Rear Amenity Space

OverView Objection

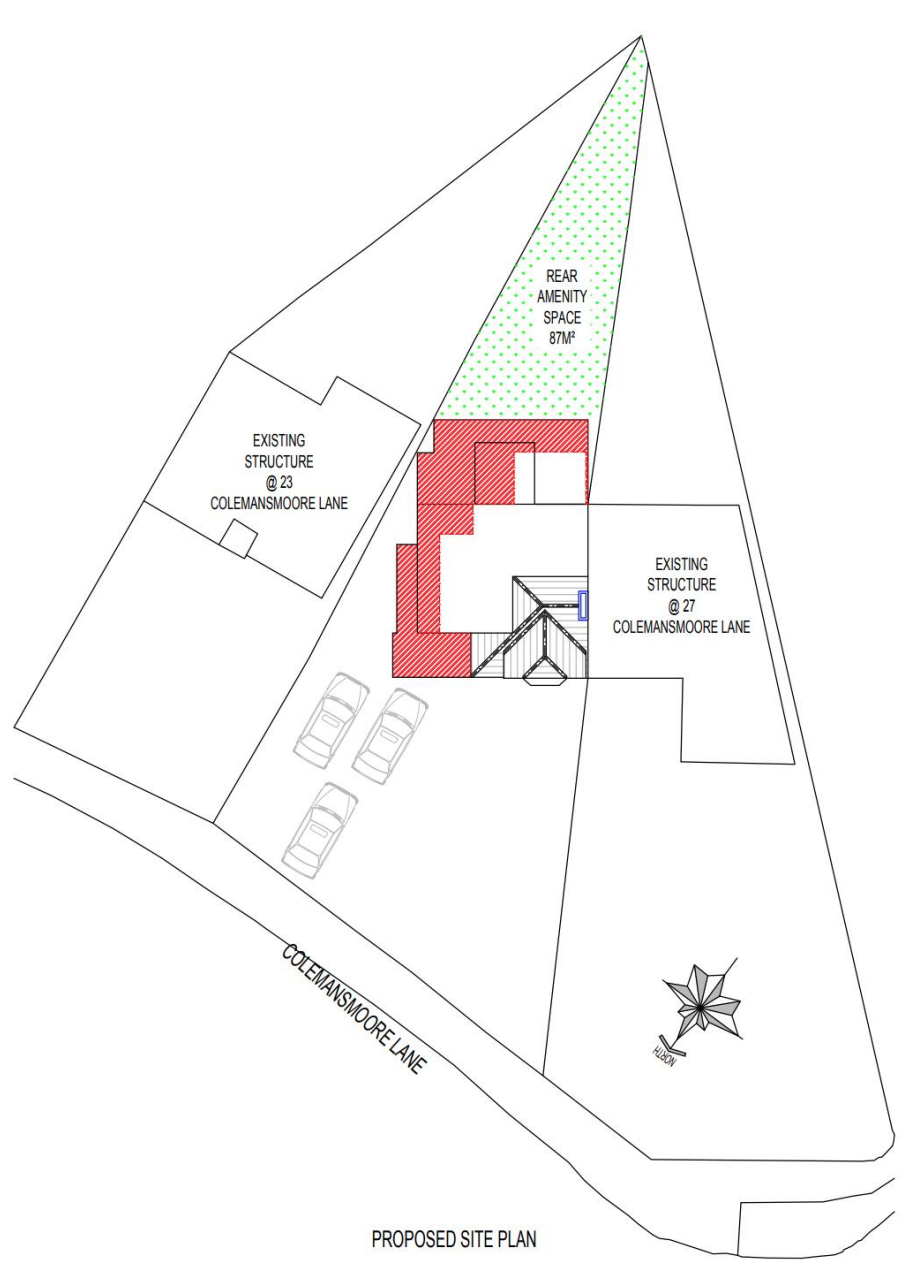
Just to confirm after proposed extension, rear amenity space will be more 85 sq. mts.

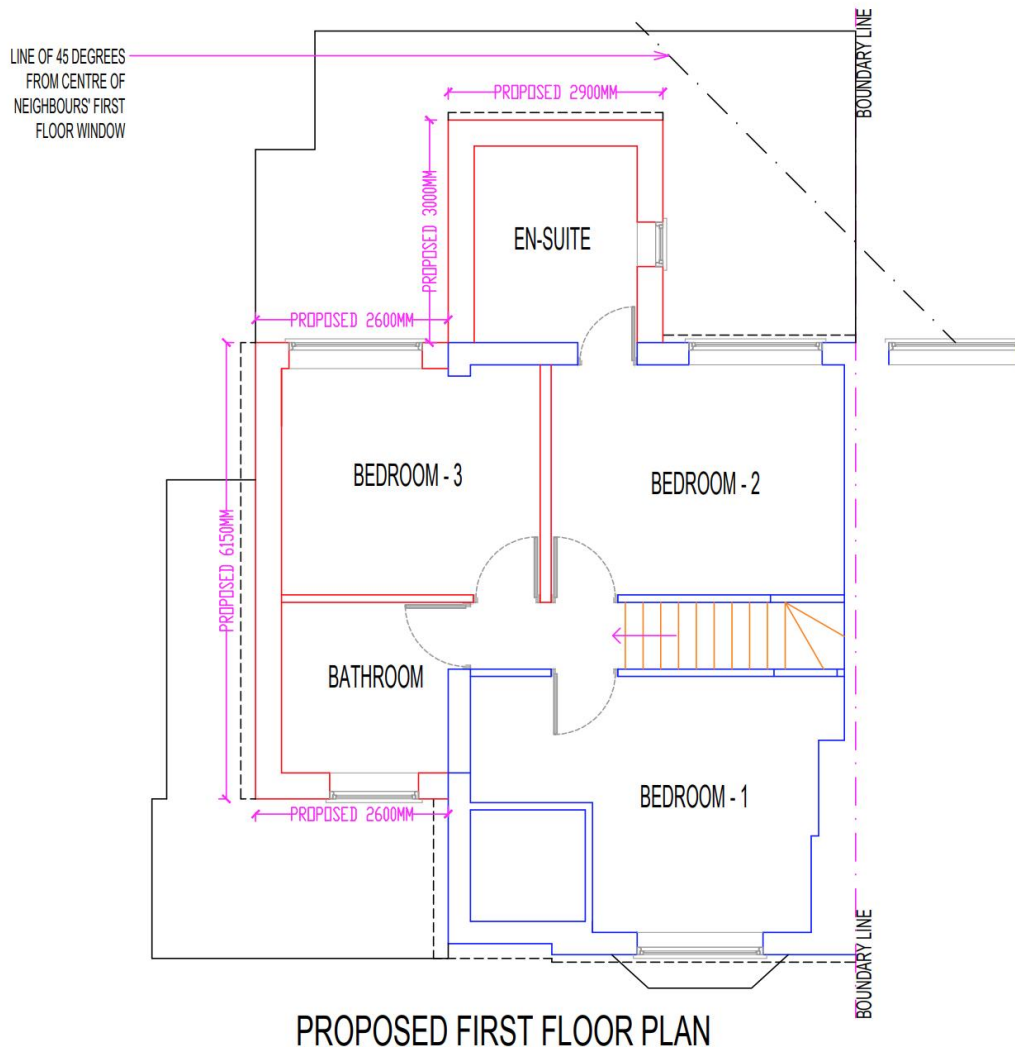
Please find marked plan to show that proposed first floor rear extension will not affect light to neighbouring first floor rear window. On other side, which is No. 23 is already set back from our rear walls.

Over Development on Side

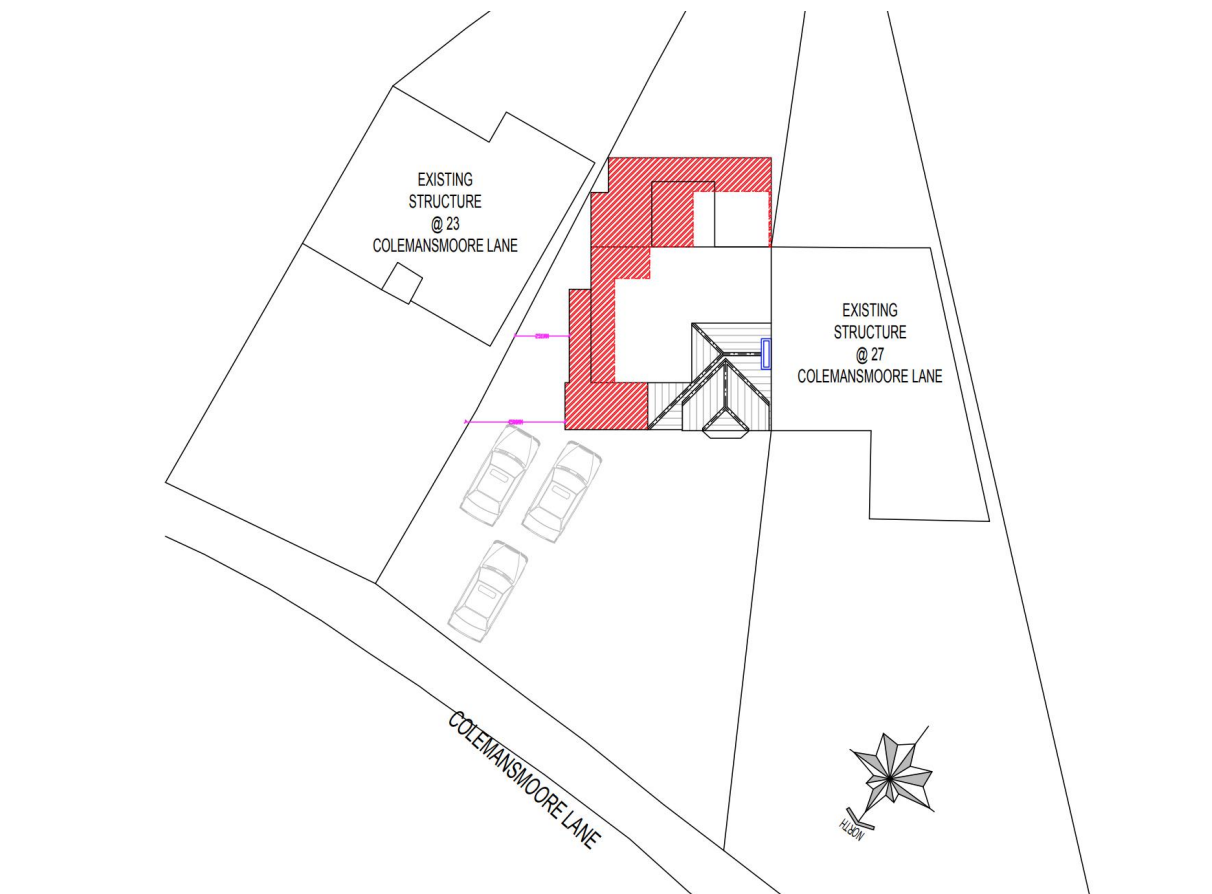
Please refer to blowup to clearly show that there will be more than 4M gap on front, so enough space between proposed flank wall & side boundary. Also to add existing extension at No. 27 goes almost up to boundary.
